UNITED STATES PATENT AND TRADEMARK OFFICE

Office Action Summary	Application No. 10/749,237	Applicant(s) KIM, JEONG-HOON	
	Examiner Lan Nguyen	Art Unit 3683

DETAILED ACTION

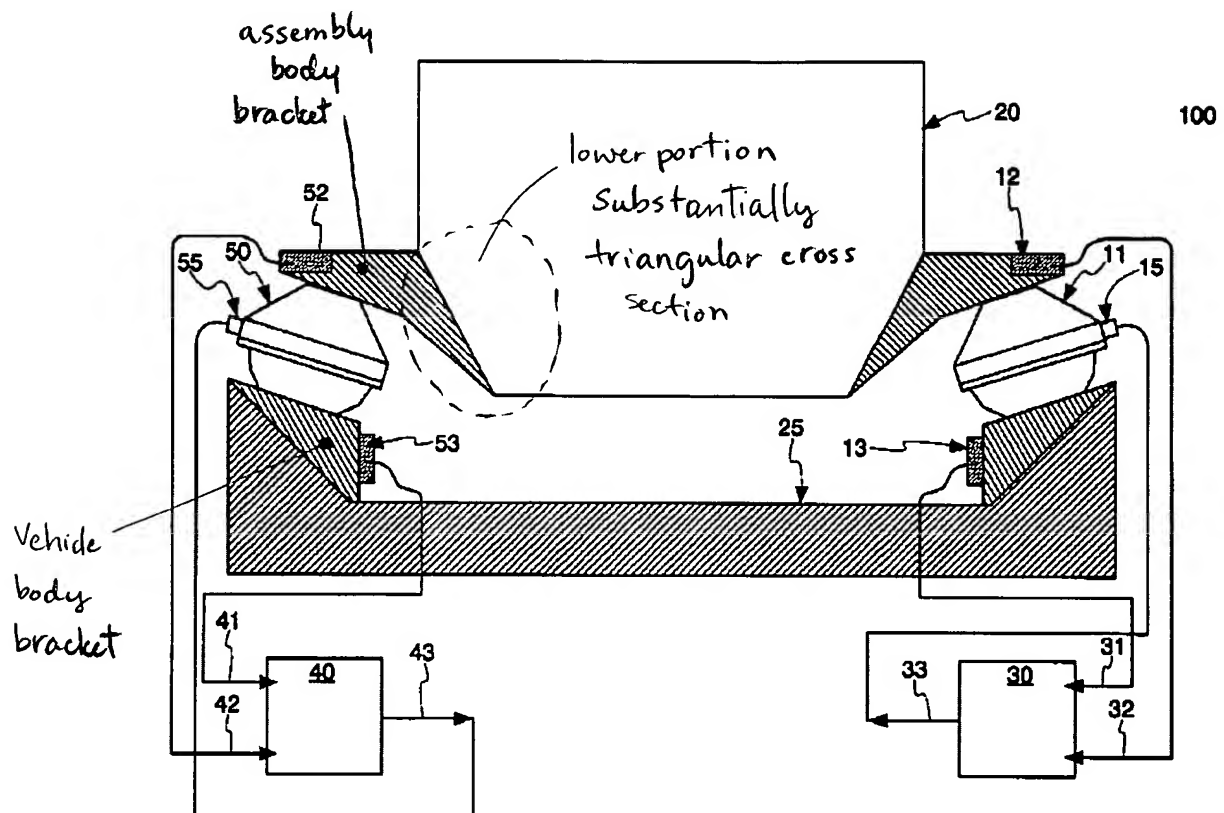
Re: claim 23, Gade et al. show a vehicle mount apparatus as in the present invention, comprising: a cushion member having two cushion block parts 11, 50, each symmetrically arranged at an incline about a vertical line and positioned in the fore and aft direction relative to a vehicle body 25; vehicle body brackets as marked above, contacting inclines of the two cushion block parts, said vehicle body brackets being configured and dimensioned for securing to the vehicle body 25; an assembly body

bracket, as marked above, contacting inclines of the two cushion block parts opposite the vehicle body brackets, said assembly body bracket configured and dimensioned to receive an assembly body 20, wherein a lower portion of said assembly body bracket comprises a substantially triangular cross-section as marked above; variable stiffness means disposed within said cushion blocks for varying the stiffness of the two cushion blocks, comprising: an magneto-rheological (MR) fluid filled in each cushion block parts; coils 15, 55 each installed to apply electromagnetic fields to the MR fluid; a sensor 12, 52, configured to output an signal in response to acceleration changes of the vehicle; and a controller 30, 40 communicating with the sensor to control the variable stiffness means by varying the stiffness of the two cushion block parts in response to the signal output by said sensor, as shown in figures 3, 4a and 4b. Gade does not show power amplifiers and the concept of controlling the dampeners asymmetrically. Kurita et al. teach the situation where the bed 1b would be pitching causing the controller 100 to vary the stiffness in block 36a (fore) and block 36b (aft) asymmetrically (i.e. the stiffness of the two cushion block parts are made to be different) in order to damp the pitching vibration due to accelerations detected by sensors 40. Kurita's vehicle mount further shows amplifier 52i. It would have been obvious to one of ordinary skill in the art at the time the invention was made to have modified Gade's apparatus to include power amplifiers and an asymmetrical stiffness controlling scheme as taught by Kurita in order to further dampen the vibration in cases where the body would pitch; therefore, further reducing the vibration of the body and providing a comfortable ride.
